Addendum No. 4

Reference: New Ogden Second District Juvenile Court
Administrative Office of the Courts – Ogden, Utah
DFCM Project No. 08284150

Addendum 003

project:	Ogden Juvenile Courthouse	**project no:**	12500
date:	2013-09-10	**no. pages:**	35
owner:	Administrative Office of the Courts		
contractor:

A1 / SF103 LEVEL 4 FLOOR FRAMING PLAN

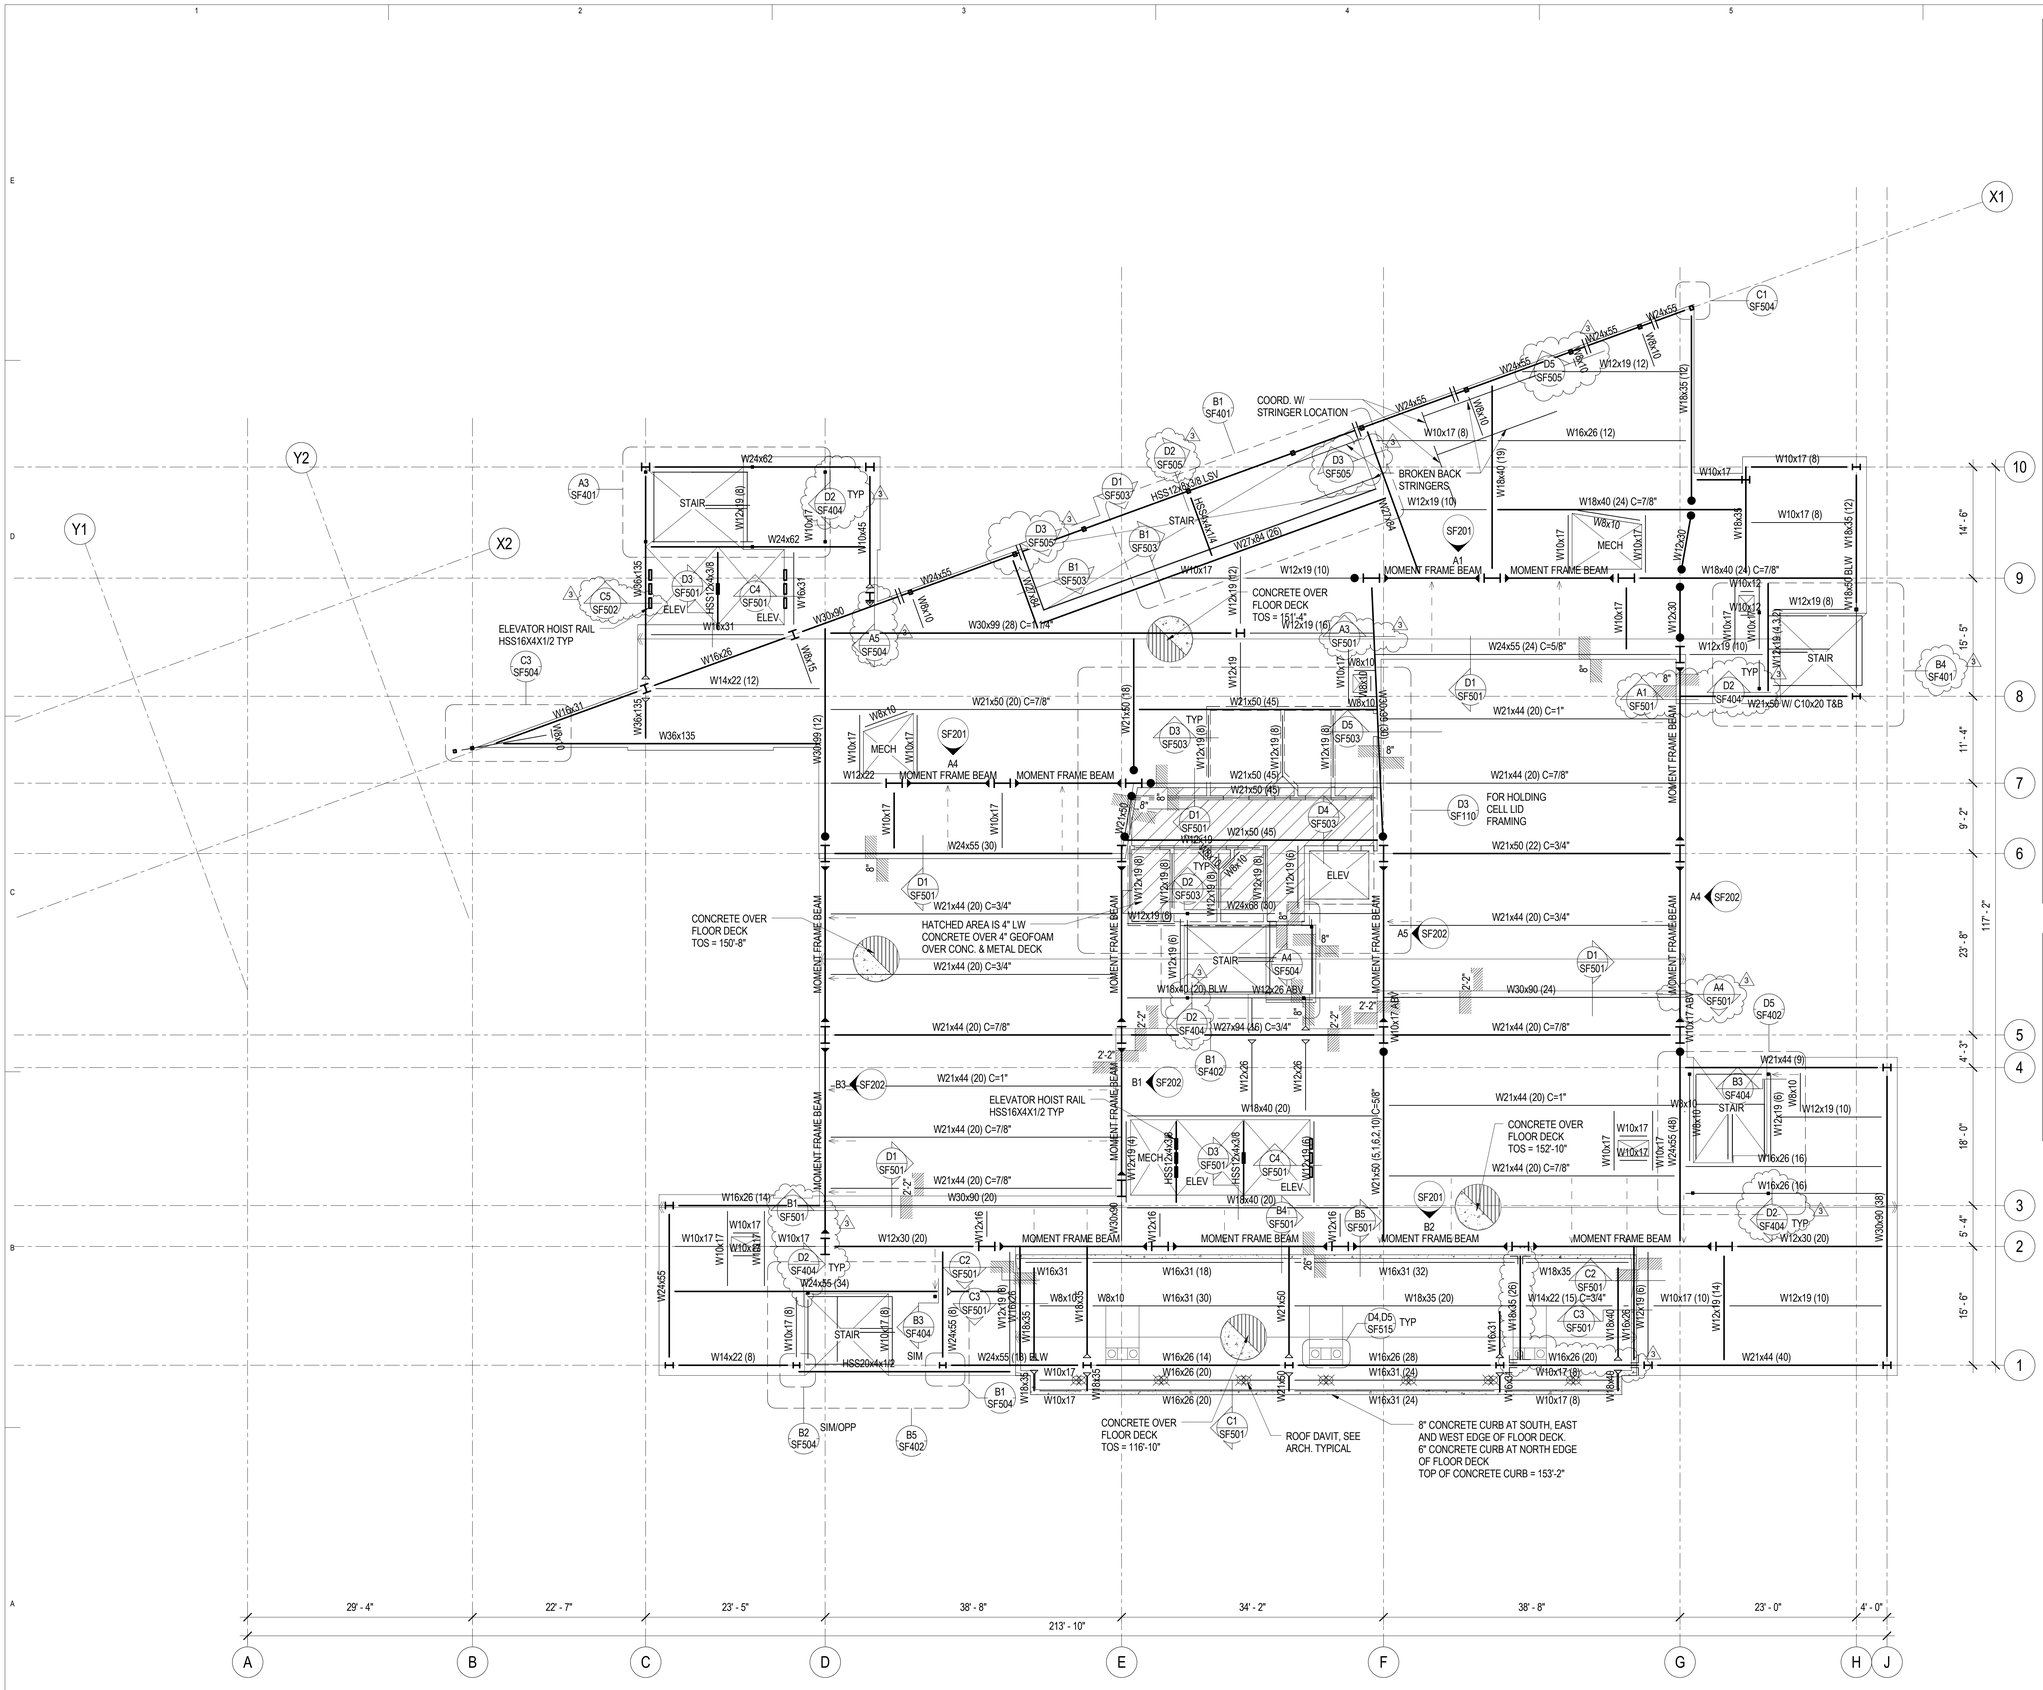
Sheet SF102 to SF104
Several details cuts added or revised clarifying existing details or added to clarify existing.

A1 SF105 ROOF FRAMING PLAN

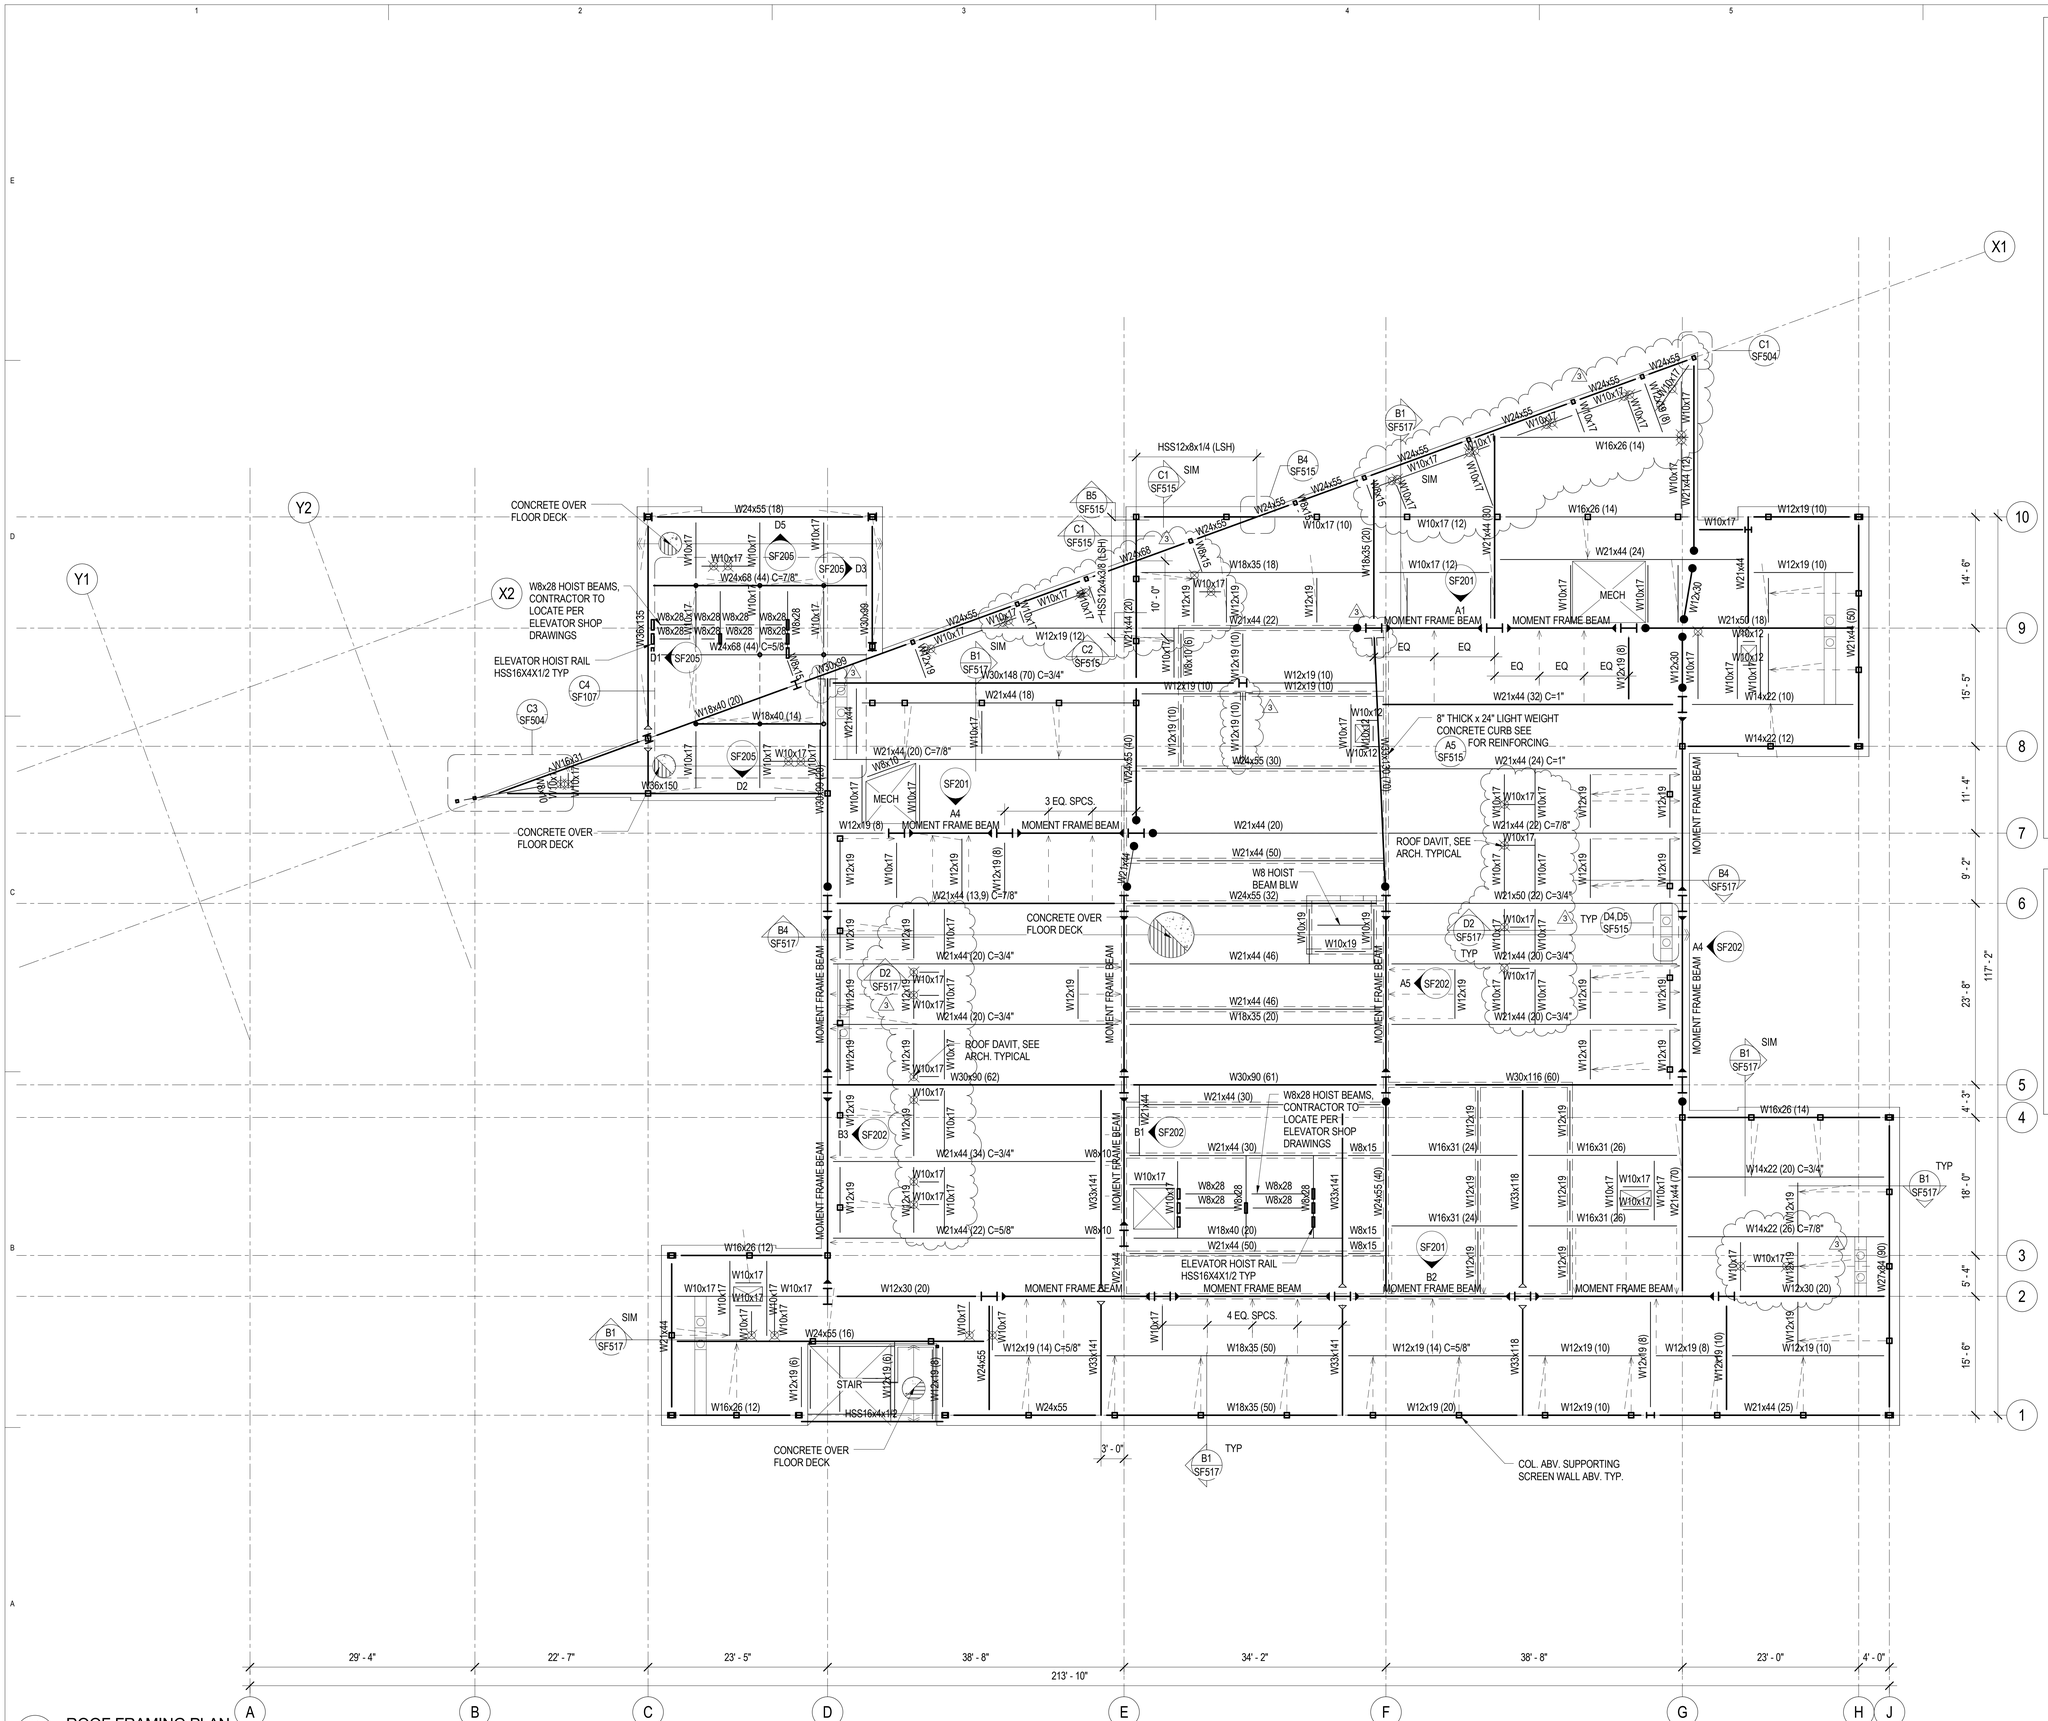
Sheet SF105
Added beams to support kickers.
Several details cuts added or revised clarifying existing details or added to clarify existing.

C2 / SF107 LOW ROOF FRAMING PLAN AT ENTRY

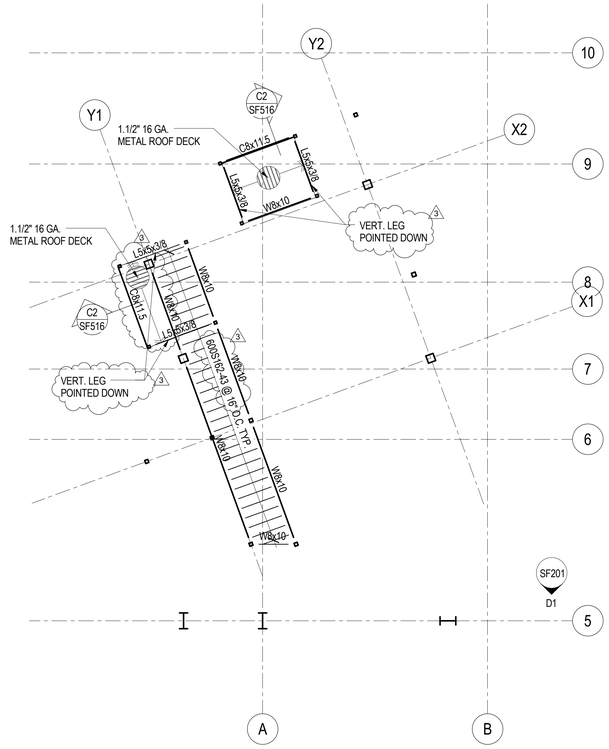
Sheet SF107
On C2/SF107 Light gage framing to vestibule size shown and clarifying the framing.

MOMENT FRAME ELEVATIONS

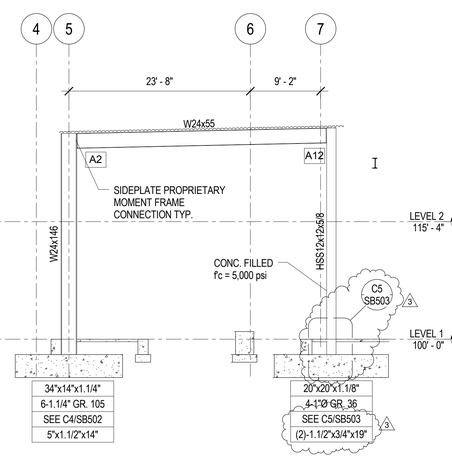
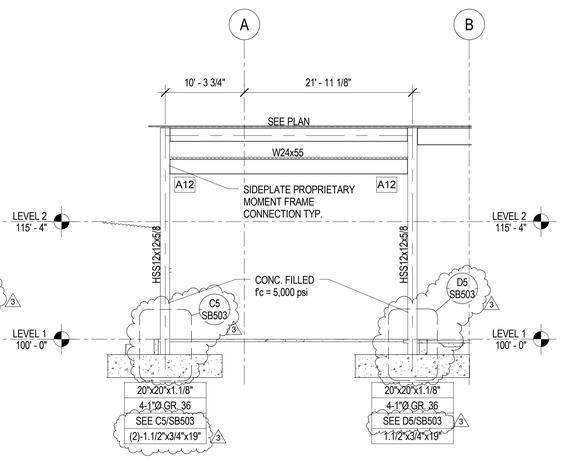
Sheet SF 201
Three detail cuts added to clarify HSS columns base plate and show the size graphically at elevations A2 and A3.

A2 SF202 MOMENT FRAME ELEVATION GRID X.2

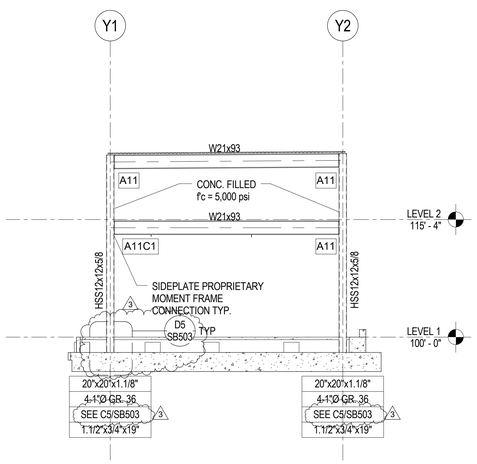
Sheet SF 202
One detail cut added to clarify HSS columns base plate and show the size graphically at elevations A2 grid Y1.

STAIR FRAMING PLANS

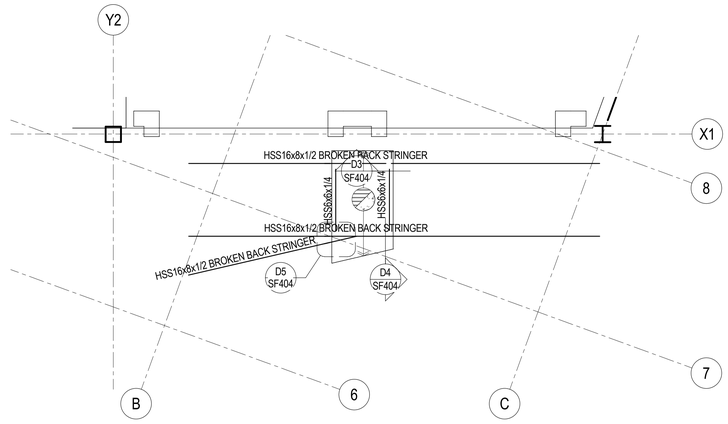
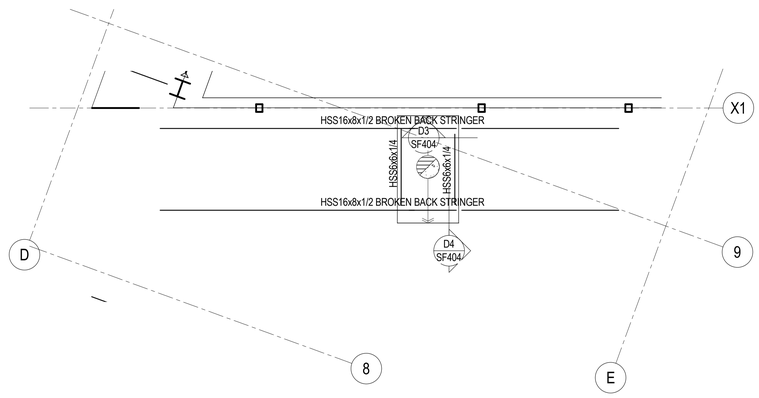
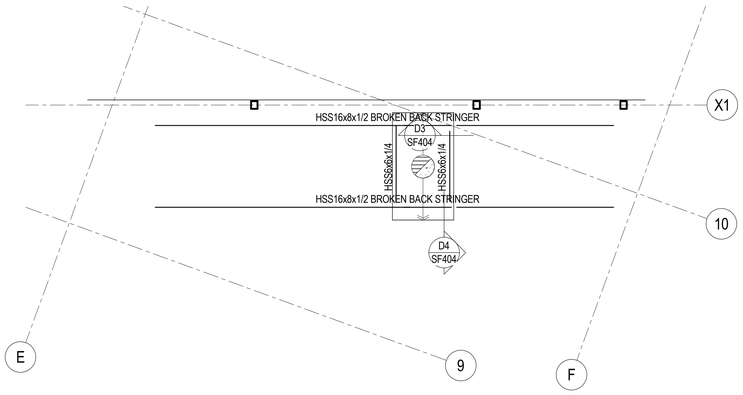
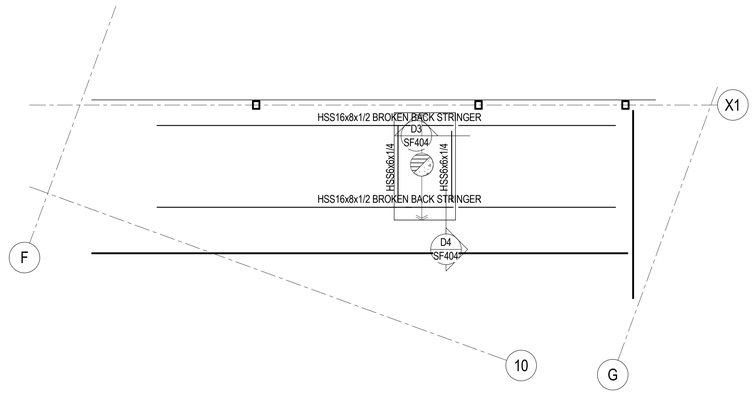
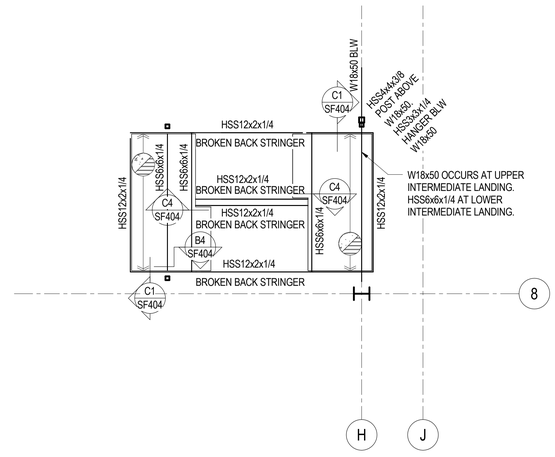
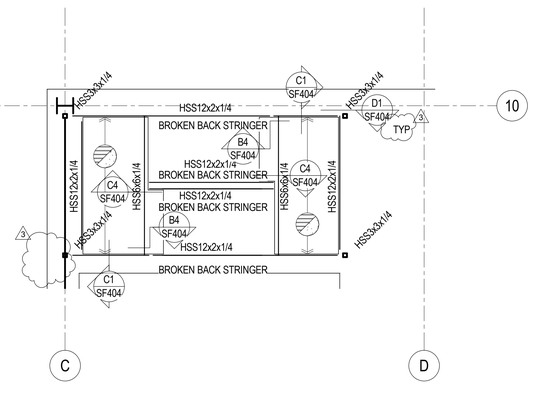
Sheet SF401 and SF402
Minor clarifications to detail cut TYP. Mainly adding TYP to detail cuts.

SF501

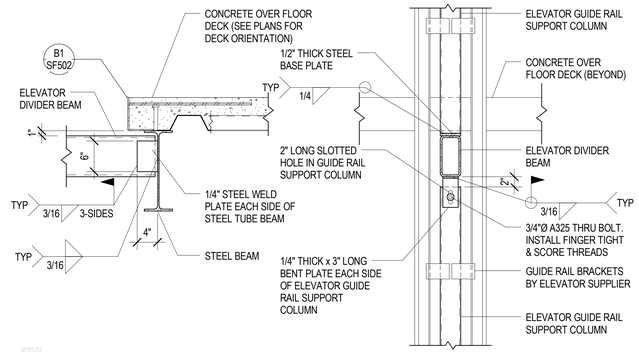
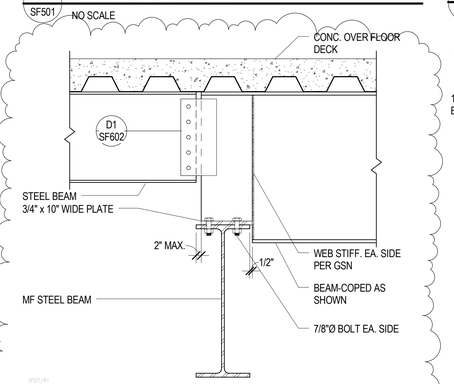
Sheet SF501
Several revisions to clarifying existing details.

C5 / SF502 TYPICAL ELEVATOR GUIDE RAIL SUPPORT CONNECTION AT UNBRACED BEAM
NO SCALE

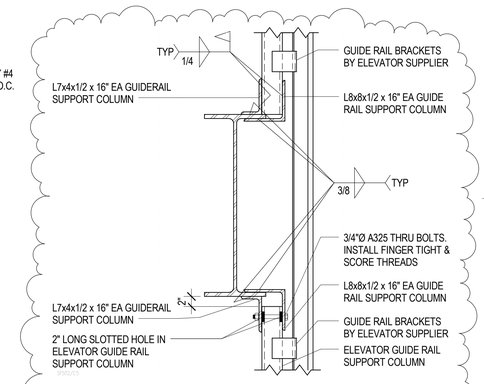
Sheet SF502
Detail C5, revised elevated guide support connection detail.

SF503

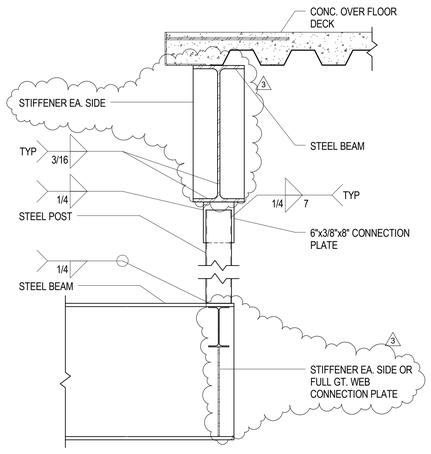
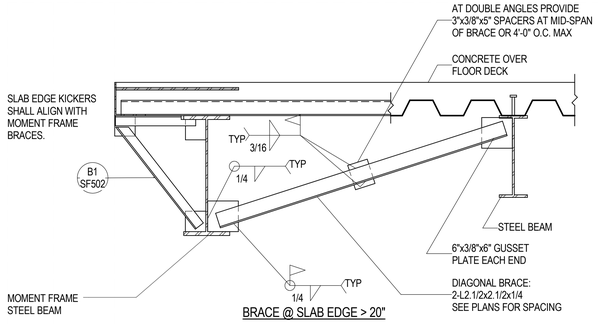
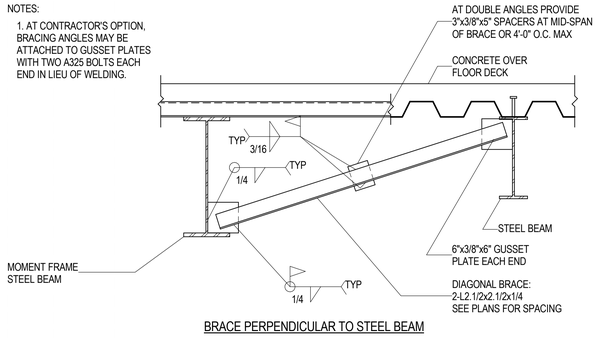
Sheet SF503 and SF504
Several revisions to clarifying existing details
